SERVICE BULLETIN

M-1242

March 16, 2009

P&A LED TURN SIGNAL CONTROLLER MOUNTING BRACKET SAFETY RECALL 0138

Figure 1. Mounting Bracket Measurement Points

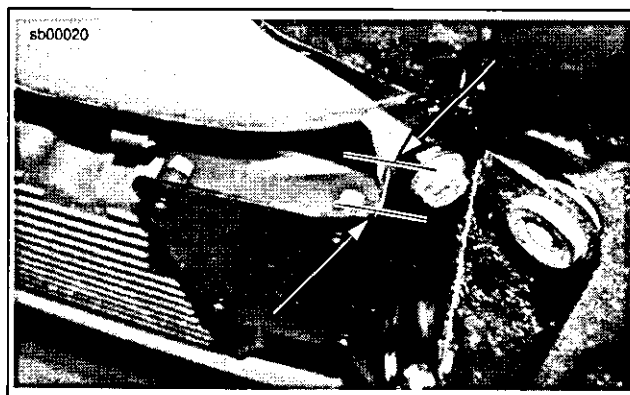
1. Inspect motorcycle for damage to oil filter due to contact from controller and mounting bracket. If damage to oil filter is observed, replace oil filter during recall procedure and file an MC warranty claim for filter and labor if motorcycle is in warranty. File a GDW claim for filter and labor if motorcycle is out of warranty. Please mention service bulletin M-1242 in claim comments.
2. See Figure 1. Use a straight edge and measure between the two points shown on mounting bracket. The old style mounting bracket will measure approximately 12.7 mm (1/2 in.) and must be replaced. The correct mounting bracket 70497-08A will measure approximately 22.2 mm (7/8 in.) and no replacement is required.

Figure 2. Mounting Bracket Installed

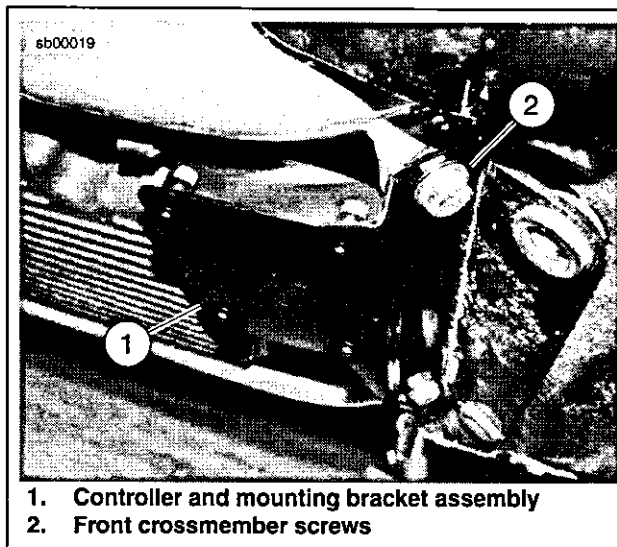
1. Remove main fuse and disconnect battery.
2. See Figure 2. Remove front crossmember screws (2) and slowly lower controller and mounting bracket away from motorcycle.

9. See Figure 2. Install controller and mounting bracket assembly (1) to motorcycle using front crossmember screws (2) removed earlier. Tighten screws to 20-26 Nm (15-19 ft-lbs).
10. Connect battery and install main fuse.
11. Verify turn signal operation.

Figure 3. Controller and Mounting Bracket Assembly

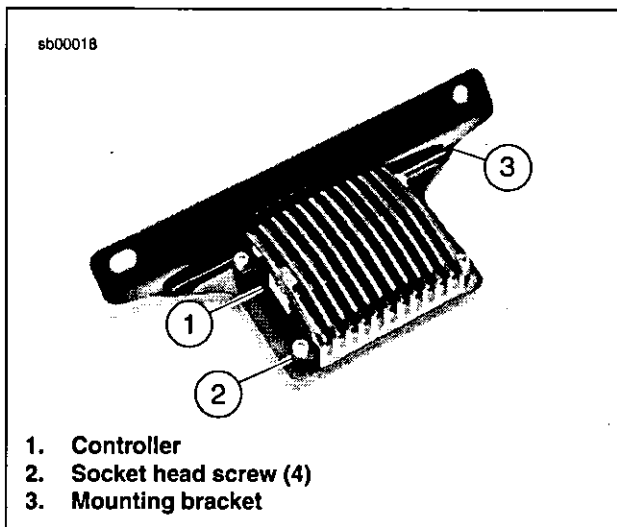
3. Disconnect wiring harness from controller.
4. See Figure 3. Remove controller (1) from mounting bracket (3) by removing four screws (2).

5. Clean any excess oil from motorcycle that may have leaked as a result of oil filter damage.
6. If necessary due to damage, install **new** oil filter and verify oil level.
7. See Figure 3. Install controller (1) to **new** mounting bracket (3) using **new** screws (2) provided in kit. Tighten screws to 5.6-6.8 Nm (50-60 in-lbs).
8. Connect wiring harness to controller.
